DEVELOPMENT REVIEW COMMITTEE (DRC) COMMENT REPORT

PROJECT NAME: Brightline Residences

CASE NUMBER: UDP-S23025

REQUEST: Site Plan Level II Review: 392 Multifamily Residential Units with 5,986 Square-Feet of Commercial Use and 2,888 Square-Feet of Restaurant Use in the Downtown Regional Activity Center

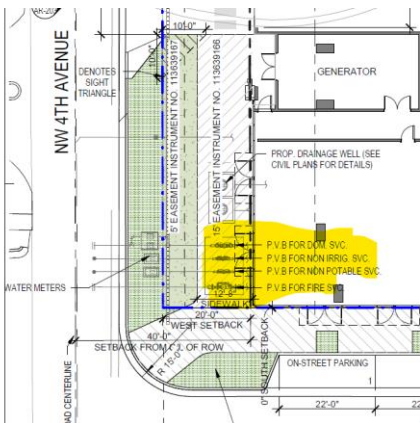
6. Remove the P.V.B's highlighted in the image below from the NW 4th Ave sidewalk clear path.

Principles of Street Design

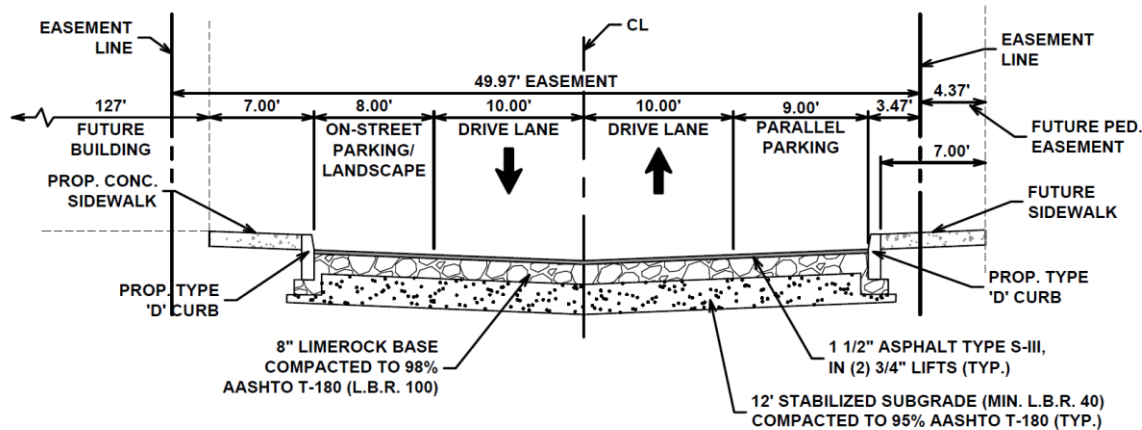
- a. Revise the street sections to clearly reflect the elements in the applicable cross section from the DMP.
 - Private driveway should include the following elements: travel lanes, on-street parking with landscape bulb-outs with street trees, and minimum 7-foot clear sidewalk .
 - NW 3rd Avenue and NW 4th Avenue should include the following elements: travel lanes, on-street parking, landscape with street trees, and minimum 7-foot clear sidewalk.
